Upper Ledge/ Base of Dome

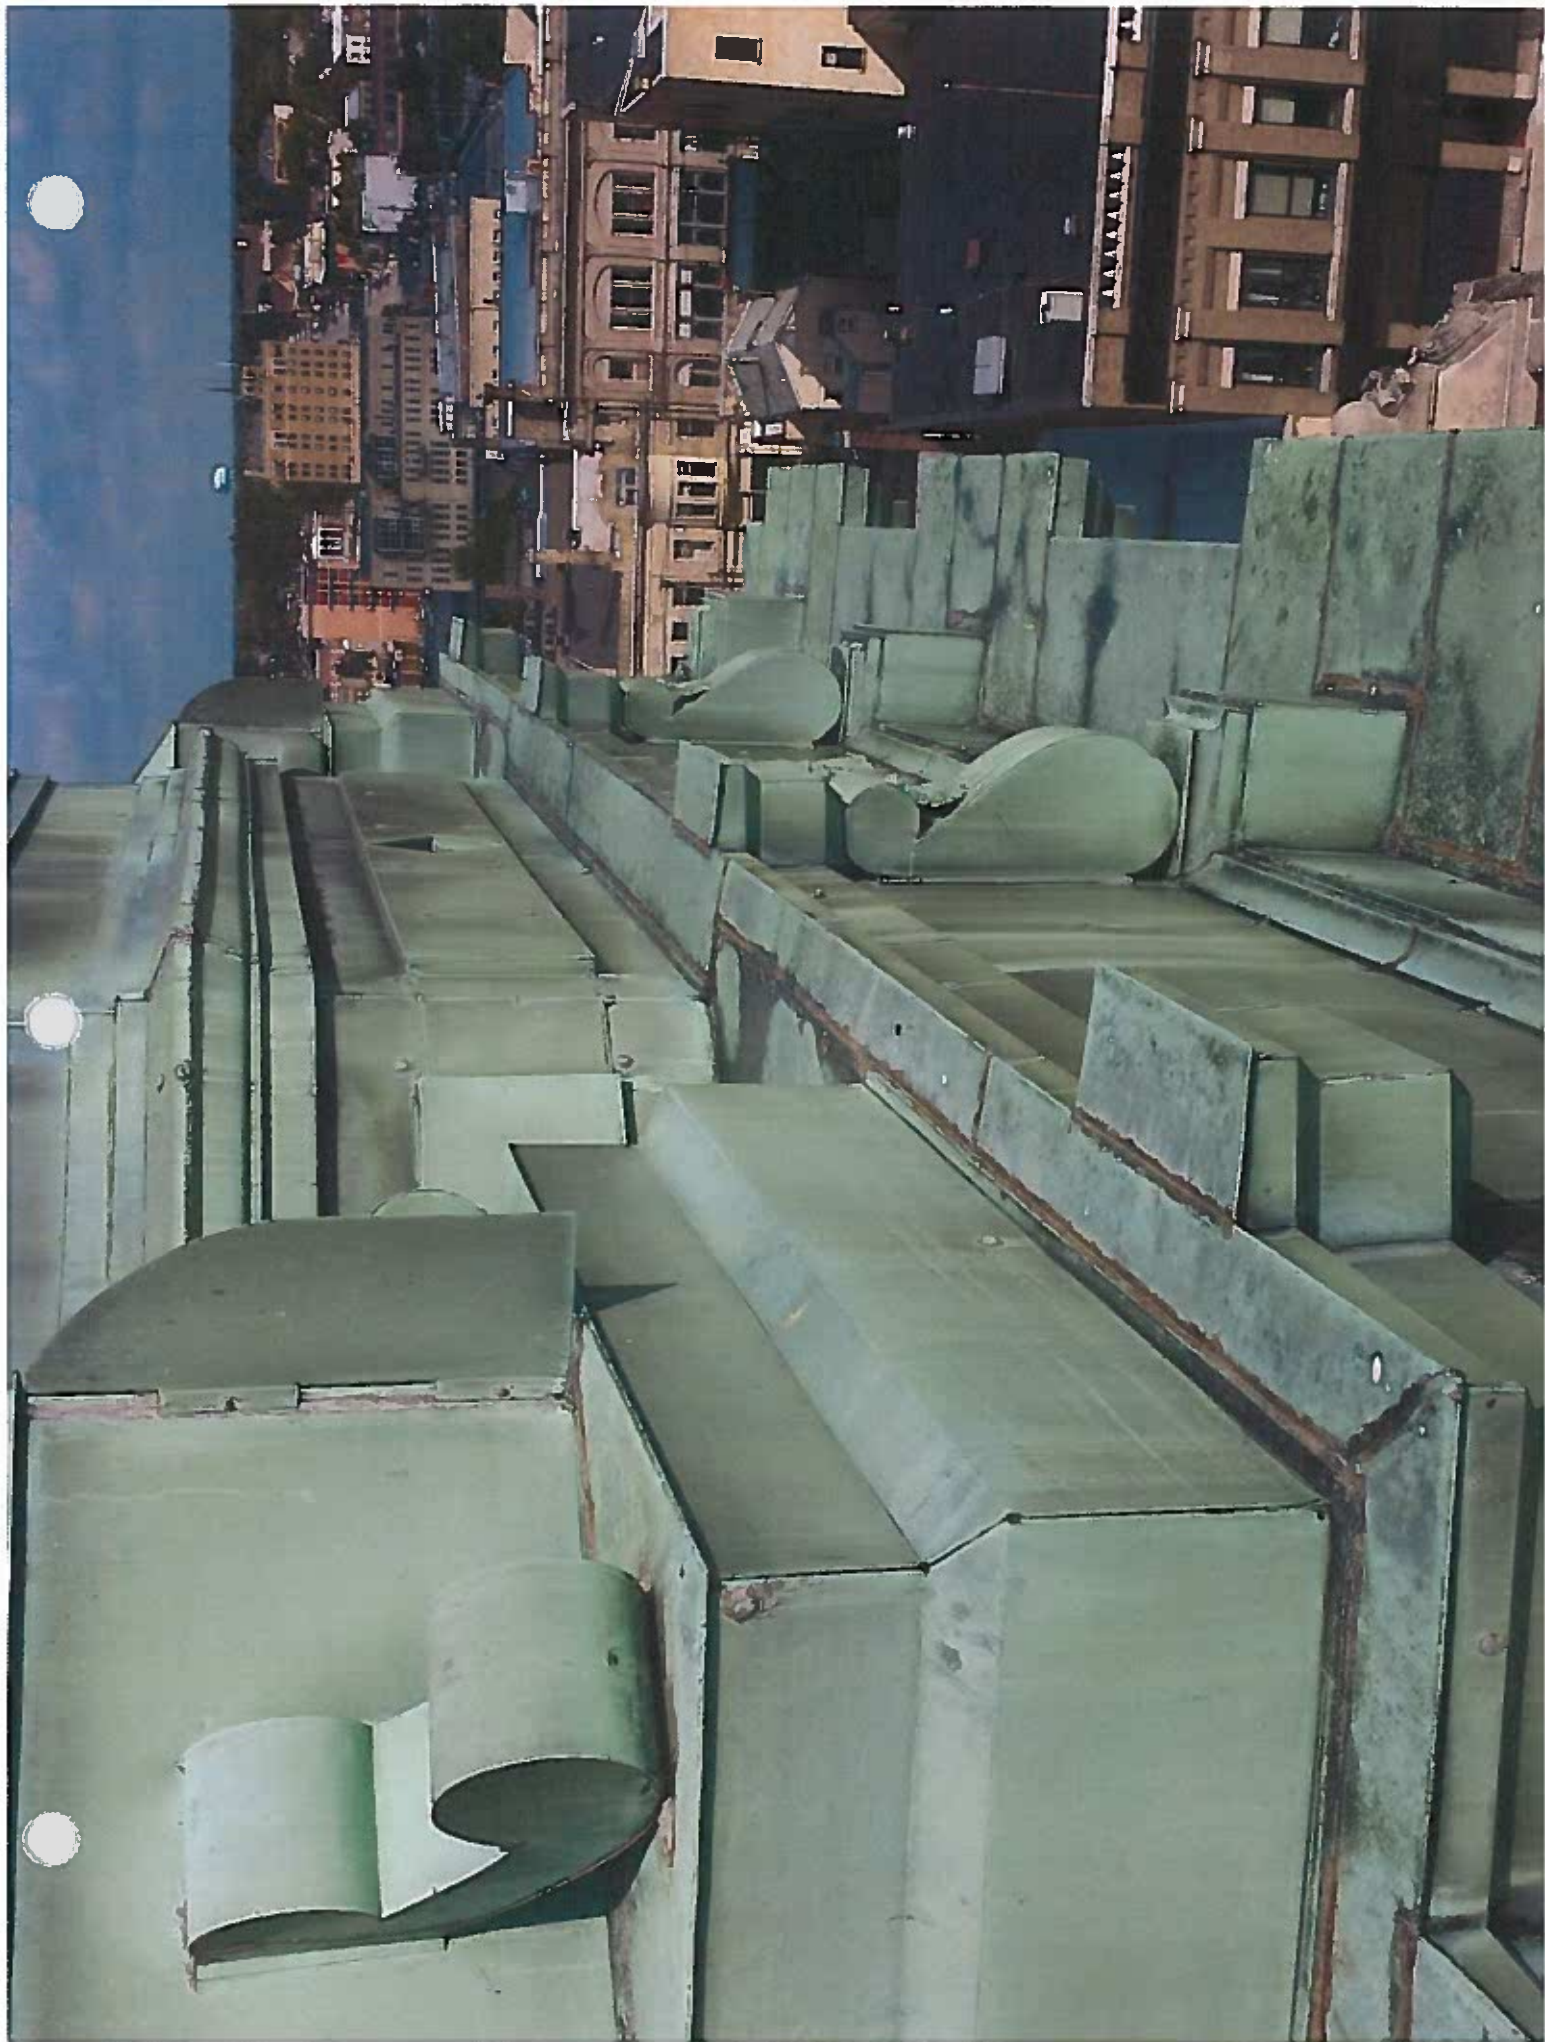
These decorative copper windows are missing

These spheres were replaced with pyramid shaped boxes

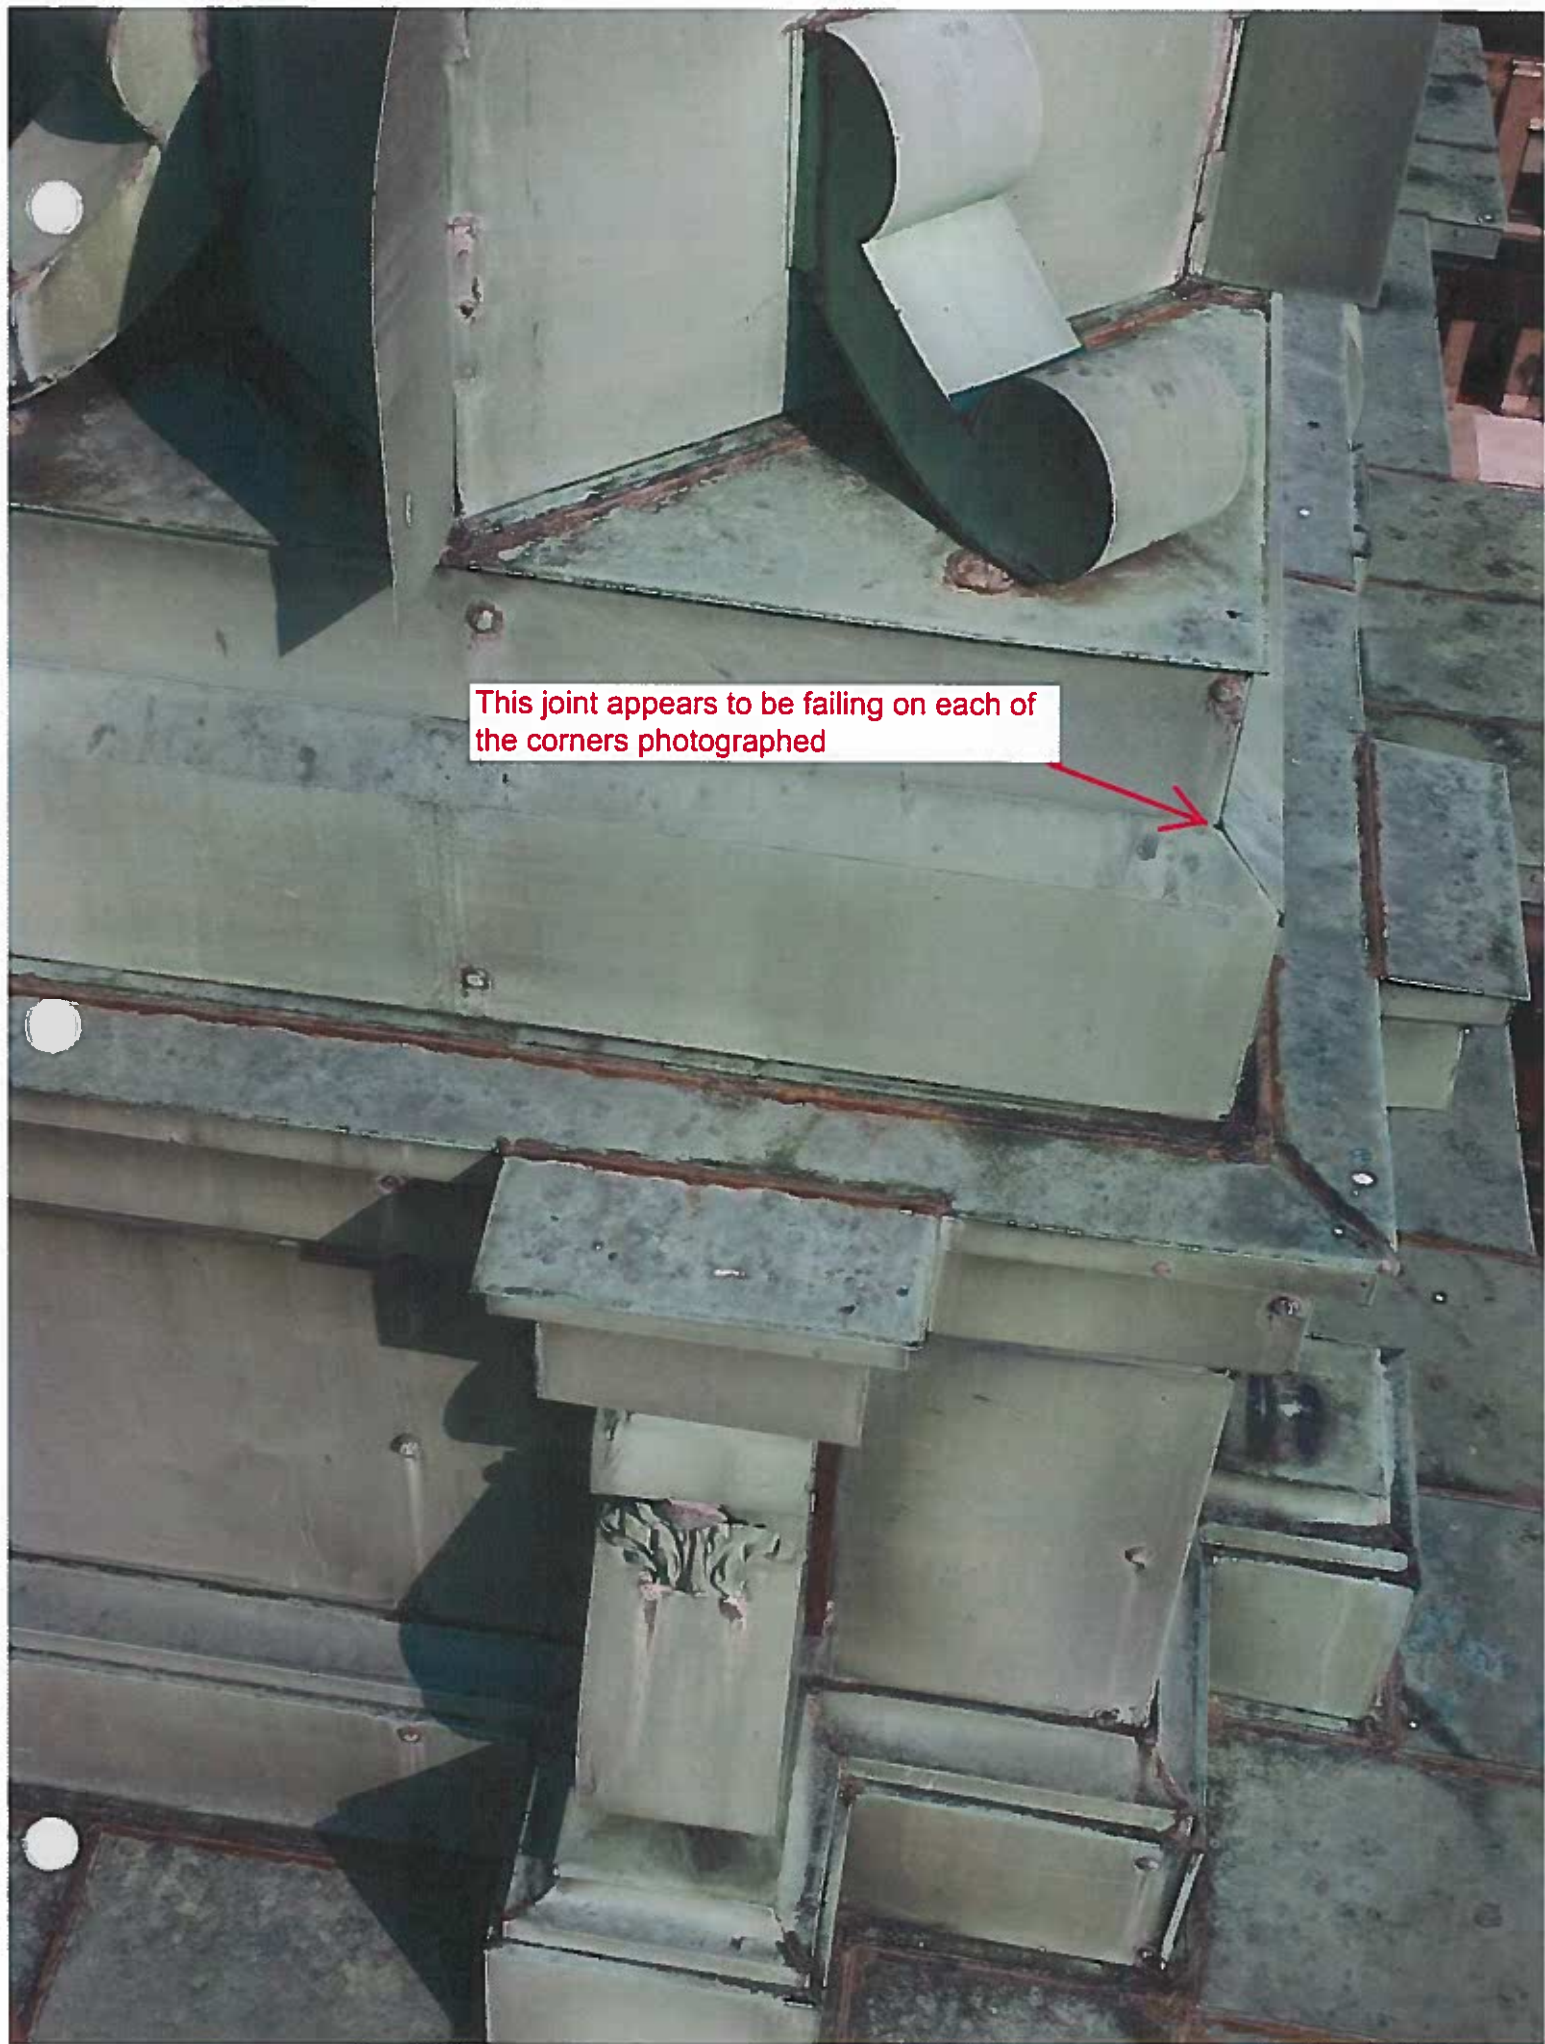
The method of using fasteners that penetrate the roofing and covering them with protective caps is not a preferred.

This joint appears to be failing on each of the corners photographed

Missing protective cap

Cracked seam

This protective cap has failed.
Letting in moisture at this location

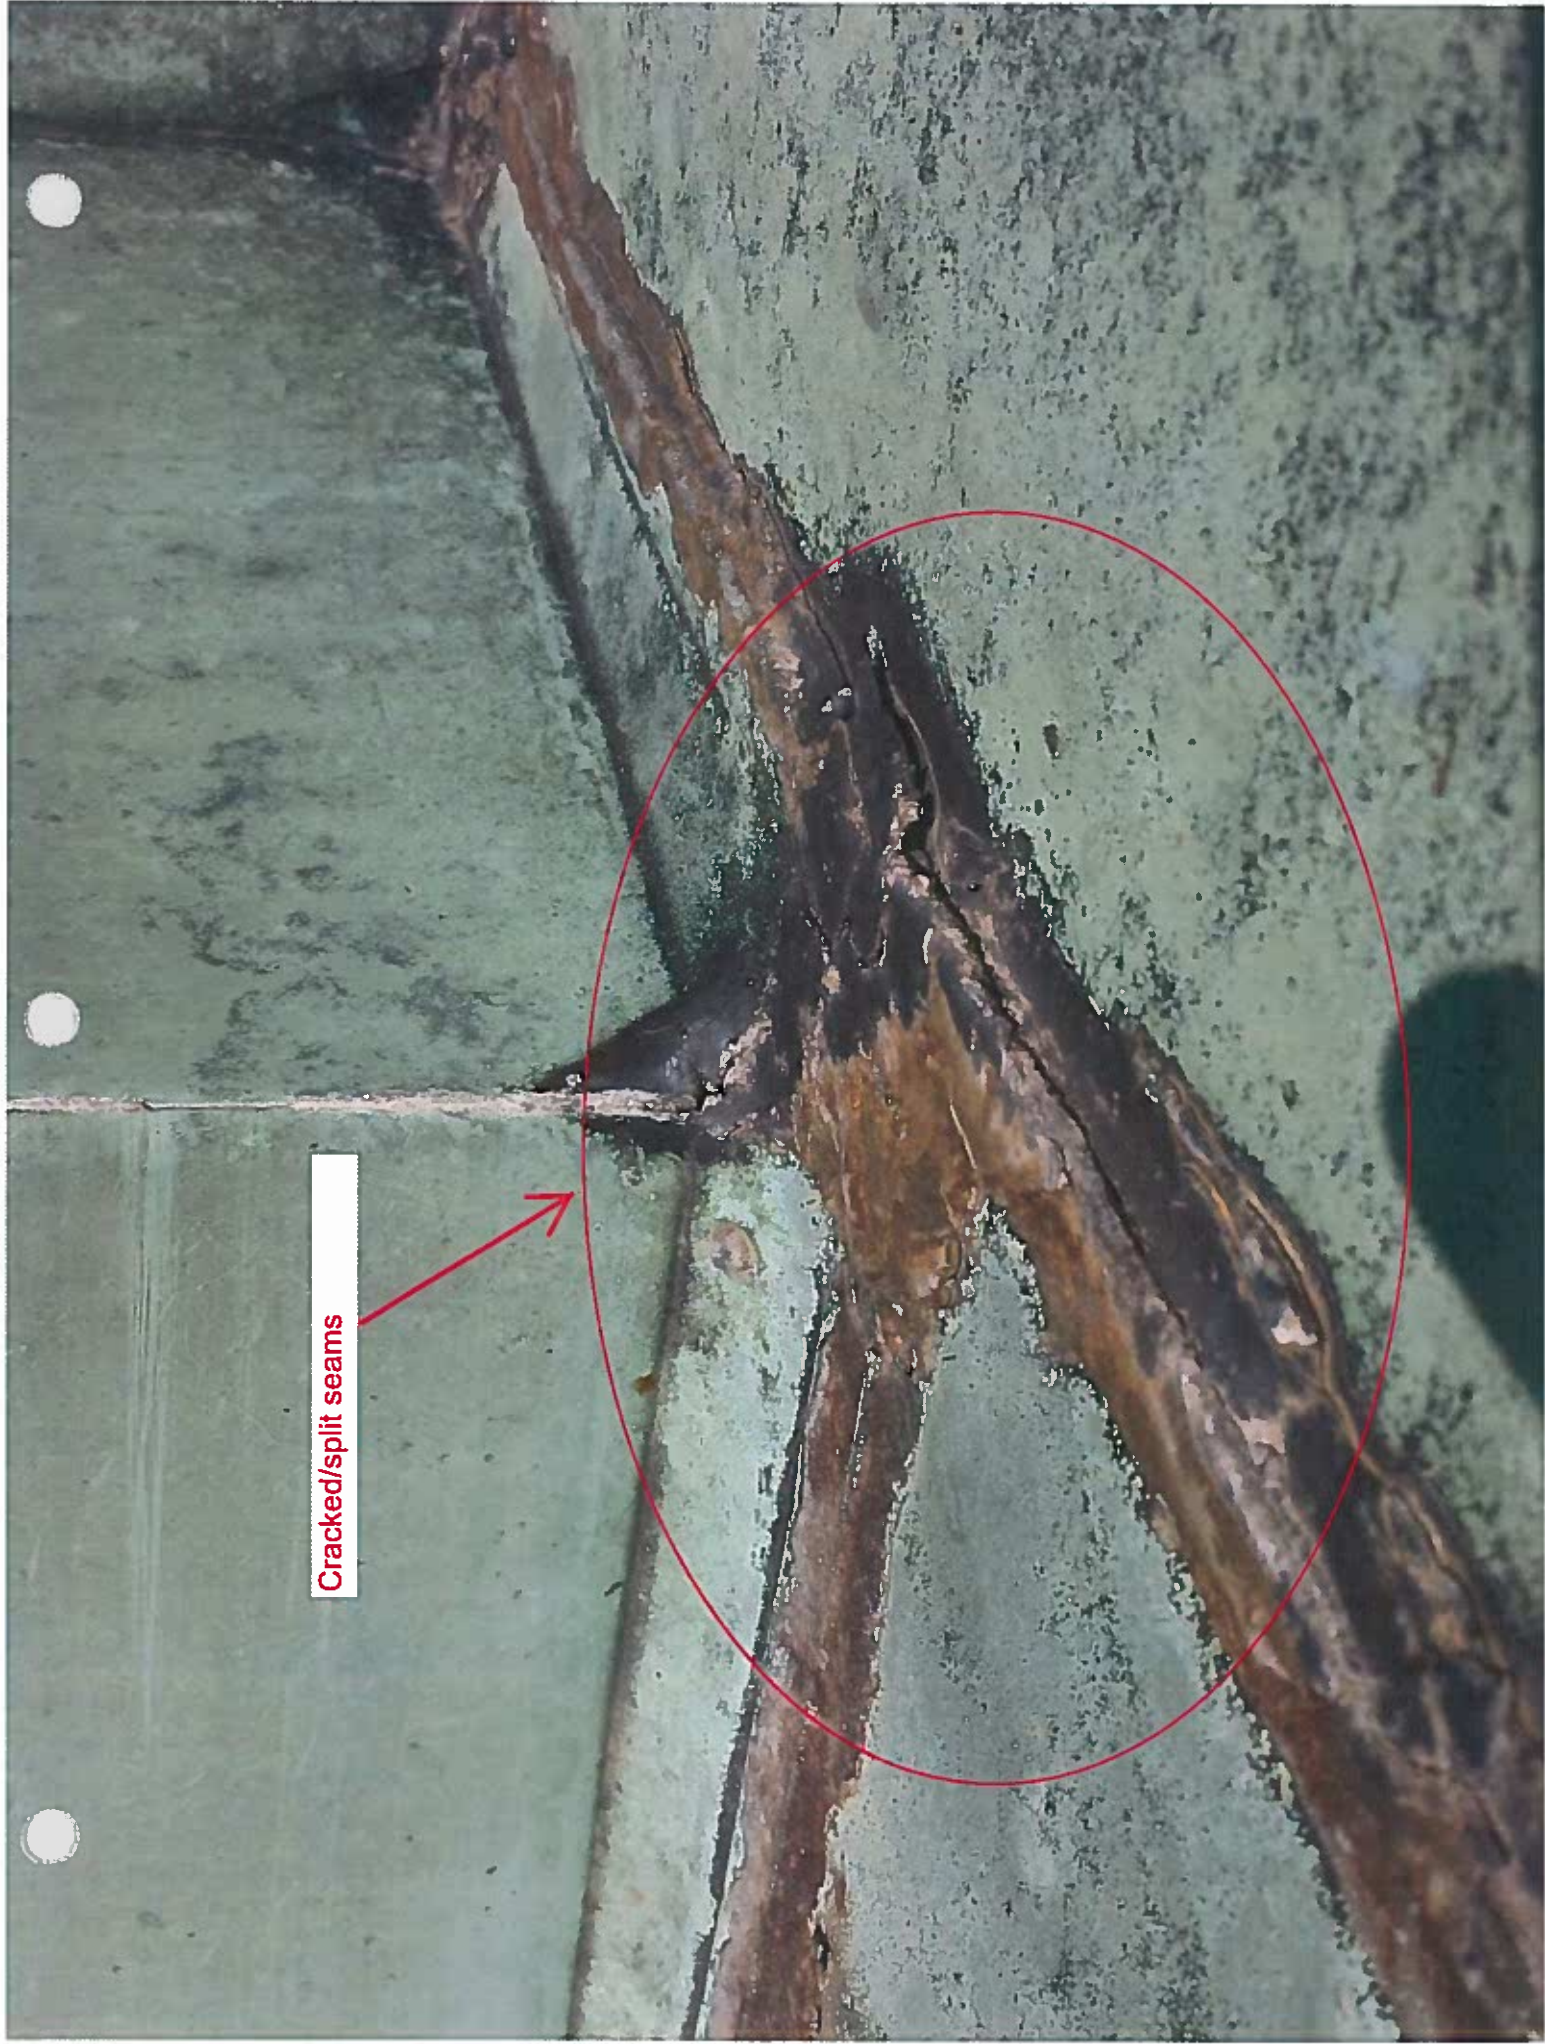
Hole in copper. Missing protective cap?

Missing cap and fastener

Cracked/split seams

Cracked/split seams

Tear in the copper

Missing fasteners and protective caps

Missing Cap

Seams splitting

Not a preferred
type of joint.

Cracked/split seam

Cracked/Split seam

Cracked/split seam
